SERVICE BULLETIN # 1099

MODEL **4-30A**

SUBJECT **MODIFICATIONS REQUIRED BY INSTALLATION OF CARBURETOR, P/N 47393**

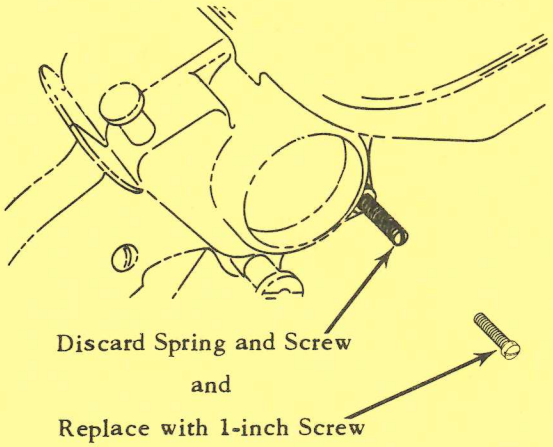
1. The fuel return tube (silver) in the fuel pump body on the bottom of the fuel tank, must be plugged. This can be accomplished by driving a small steel ball or a piece of lead or solder into the tube. The fuel return hose can be discarded. Do not confuse the two hoses and tubes. The fuel return is silver; the fuel delivery is black.

2. Remove the idle air bleed spring and screw and replace them with a 1/4-28 x 1 inch long Fillister head screw. This will block the air bleed, permitting idle adjustment to now be made by changing the position of the needle valve on the rear of the carburetor.
